**Remarks**

**Claims 1-9 are currently pending in the application.**

FIG. 6

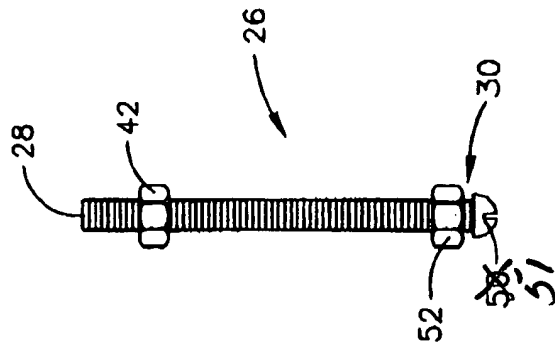
**The drawings stand objected to in that: 1) the reference character “50” has been used to designate two elements of the apparatus; and 2) the reference numeral “51” while mentioned in the specification is not shown on the drawings. The numeral “50” has been deleted from Figure 6 and the numeral “51” substituted therefore to eliminate this confusion.**

**In Figure 6, delete “50” and substitute therefore - - 51 - -;**
